# CITY OF ALBUQUERQUE

RE: **Pitcher Residence**  
**12000 San Antonio NE**  
**Grading Plan Stamp Date: 11/14/19**  
**Hydrology File: E22D007H1**

Based on the submittal received on 11/18/19, the grading plan cannot be approved until the following corrections are made:

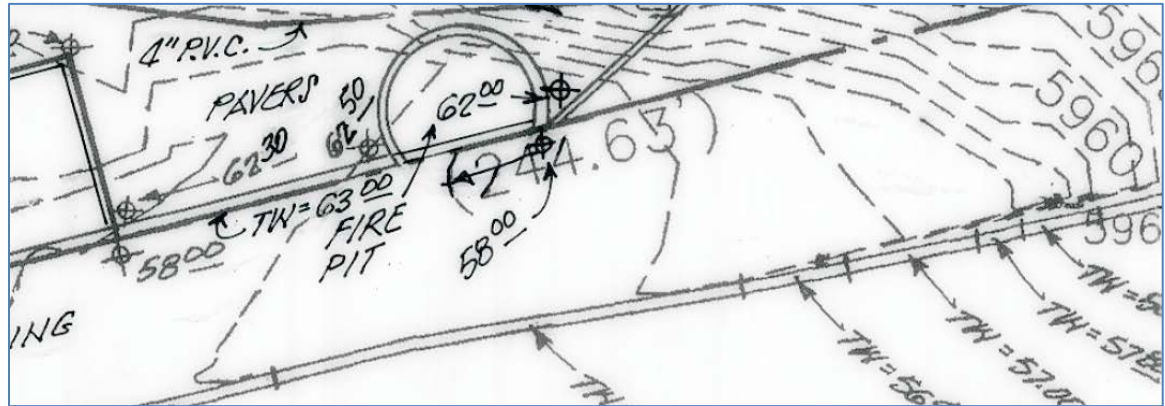
1. Show all easements of record and any utilities.
2. Do not cut the grade or place and buildings in the PUE.
3. Provide written and signed permission from PNM for grading, paving and building construction in their easement.
4. Provide written and signed permission from the property owner to the south to discharge to their property. Per the approved conceptual grading and drainage plan for this site, no discharge to the south was permitted.
5. Along the south property line, why are the spot elevations on the golf course property shown as several feet higher than the contours? If these are proposed elevations, provide written and signed permission from the adjoining property owner for grading their property. If this is new

survey, then the contours should match:

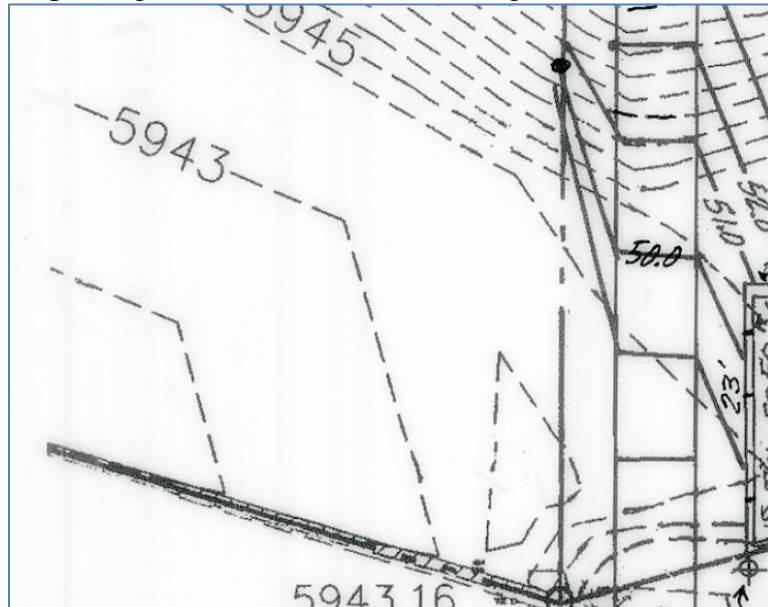
7. Proposed grades do not tie-in to existing at the SW corner:
